B U R G I S  
A S S O C I A T E S , I N C .

May 22, 2025

Re: Adoni Property Group, LLC, v. Township of Middletown and Mayor & Council of Township of Middletown  
Docket No. MON-L-1260-23  
BA#: 4175.00

Pursuant to my latest meeting with the Township and the Adoni representatives, I have prepared this report regarding the suitability of Adoni's two properties, namely the West Nut Swamp Road property and the Red Hill Road site, for multi-family inclusionary development. I am submitting this report in my capacity as Special Adjudicator in the above captioned matter.

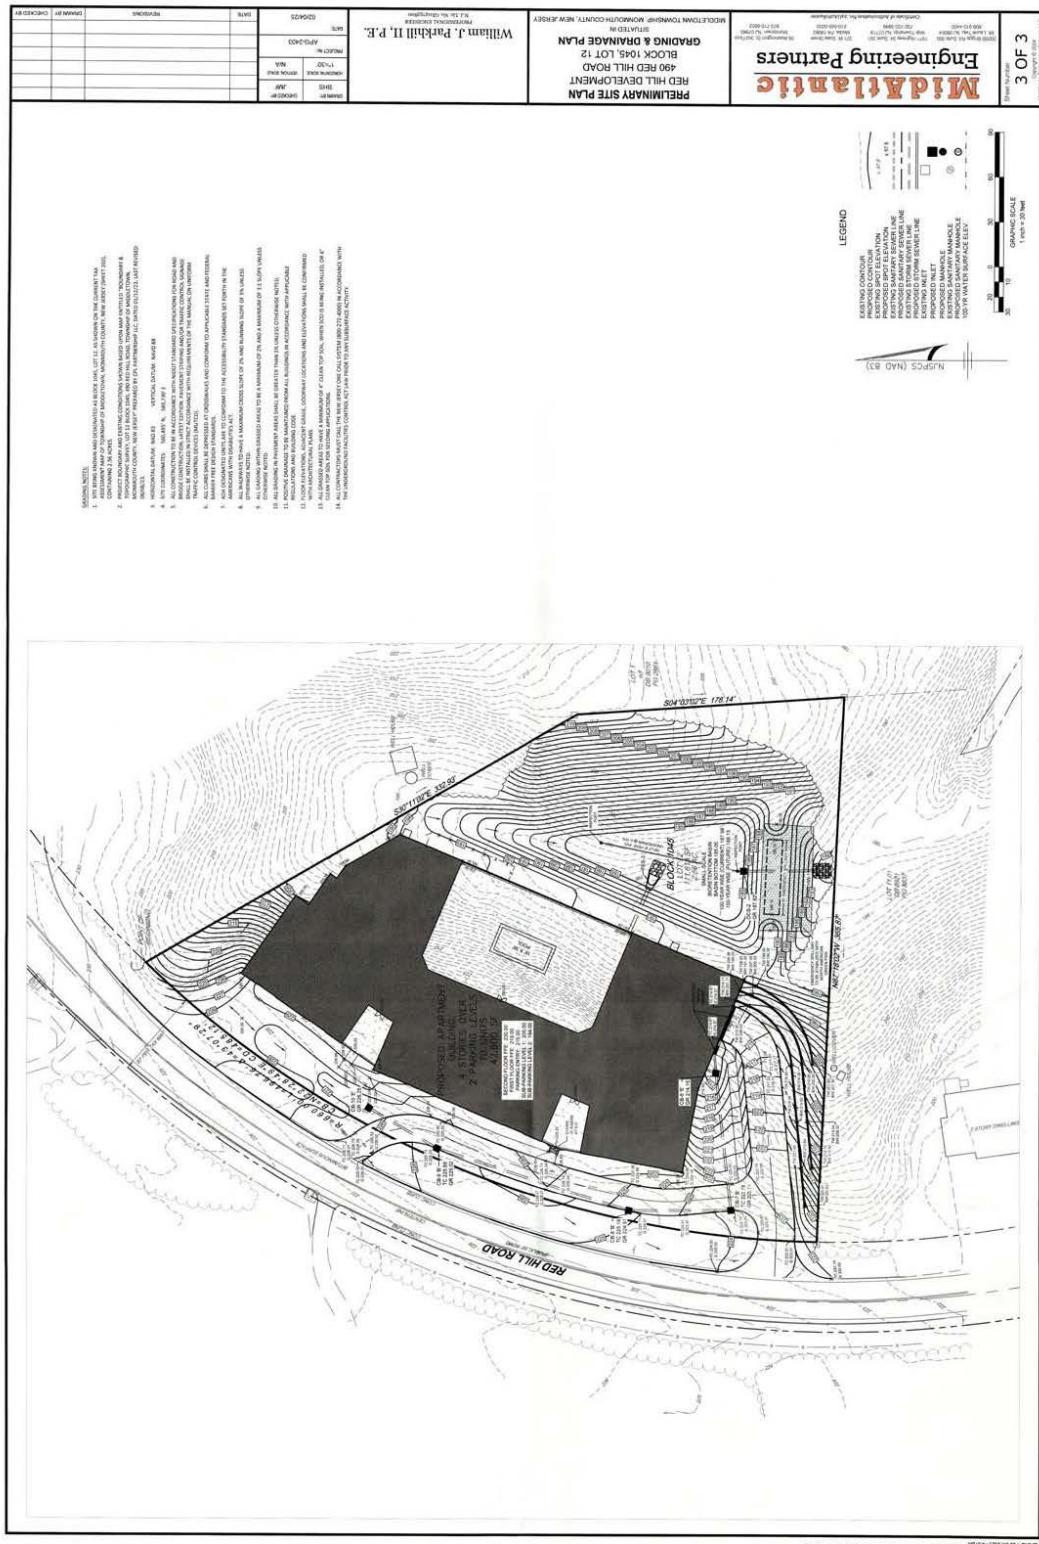
The critical component of the site suitability criteria with respect to this site regards the issue of site suitability, and particularly the application of the steep slope exclusions noted above. As detailed in a previous section of this report, the property is characterized by a steep topography, with nearly 60 percent of the property, accounting for nearly 1.5 acres of the 2.56-acre lot, characterized by slopes of greater than 15 percent gradient. Notably, more than half of that total is characterized by slopes of 25+ percent grade. These steep sloped areas of the site extend throughout the central and easterly portions of the property; it is the location where a significant portion of the proposed building is to be placed.

conventional ordinance steep slope ordinance restrictions, should prevent the project that is contemplated by the developer. Furthermore, the Township's professionals raised concerns about a variety of issues, notable amongst them are issues regarding the building's height (6 stories in the rear) and building configuration and orientation that adversely impacts the ability of emergency services to serve this building, along with concerns regarding the proposed vehicular egress movements, all of which have merit and were not satisfactorily addressed during discussions on this matter.

Consequently, it is recommended that, in recognition of the Township's outstanding affordable housing shortfall, consideration be given to a design that concentrates development in the westernmost portion of the site wherein slopes are moderate. There is an area immediately off of the right-of-way, varying in depth from approximately 50 feet to 90 feet, wherein development within the context of townhouse or other similar configuration that orients development close to the street could occur. In this way development that would significantly intrude into the steep slope portions of the site can be avoided. It would also possibly enable a modest level of development that could result in a small additional number of affordable units to be developed and add to the Township's affordable housing inventory.
